Access Compliance Report

Public Rights-of-Way

Intersection ID: 32179	Main Street: AMONTILLADO_DR	Cross Street: MARIE_ROGET_WY	Location: S
ADA ID: F17B2B4D661B	Ramp Type: PerpDiag	Initial Pass/Fail: Fail	Overall Compliance: No
Severity Score: 21.25			
Codes/Mitigation Info/Possible Solution		Field Measurements/Component Compliance

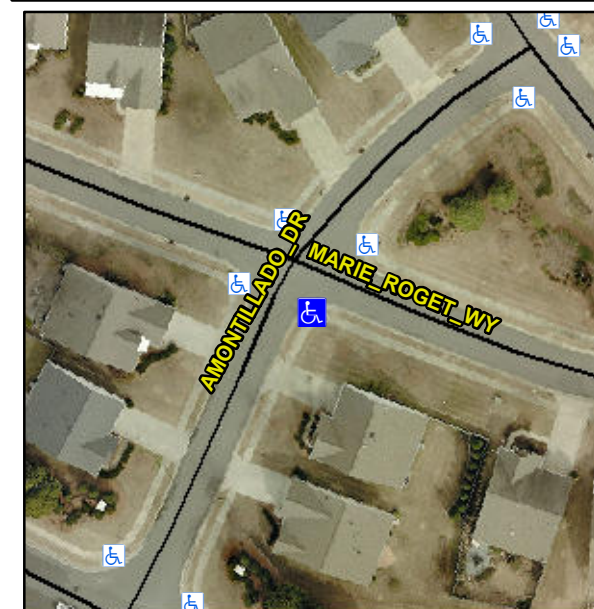
Not Found, R304.5.1, R304.5.3

Compliance	Description	Data	Compliance	Description	Data
N/A	Ramp Length (in)	96.0	Yes	Ramp Slope (%)	5.0
No	Ramp Width (in)	44.0	No	Ramp XSlope (%)	6.4
N/A	Flare Type LT	N/A	N/A	Flare Type RT	N/A
N/A	Flare Slope LT (%)	N/A	N/A	Flare Slope RT (%)	N/A
N/A	Flare Traversable LT?	N/A	N/A	Flare Traversable RT?	N/A
N/A	Landing Length (in)	N/A	N/A	DWS Provided?	N/A
N/A	Landing Width (in)	N/A	N/A	DWS Contrast?	N/A
N/A	Landing Slope (%)	N/A	N/A	DWS Length (in)	N/A
N/A	Landing X Slope (%)	N/A	N/A	DWS Full Width?	N/A
N/A	Landing Curb? (Y/N)	N/A	N/A	DWS Offset (in)	N/A
N/A	Shared Landing?	N/A			
N/A	Gutter Ponding?	N/A	N/A	Gutter Slope (%)	N/A
N/A	Gutter Lip Ht (in)	N/A	N/A	Gutter X Slope (%)	N/A
N/A	Painted X Walk1?	No	N/A	Painted X Walk2?	No
	X Walk 1 Direction	To NE		X Walk 2 Direction	To NW
N/A	X Walk 1 Width (in)	N/A	N/A	X Walk 2 Width (in)	N/A
	X Walk 1 Slope (%)	1.1		X Walk 2 Slope (%)	2.7
	X Walk 1 X Slope (%)	3.4		X Walk 2 X Slope (%)	0.6

Remove & Replace Curb Ramp With Two New Directional Ramps or Equivalent.
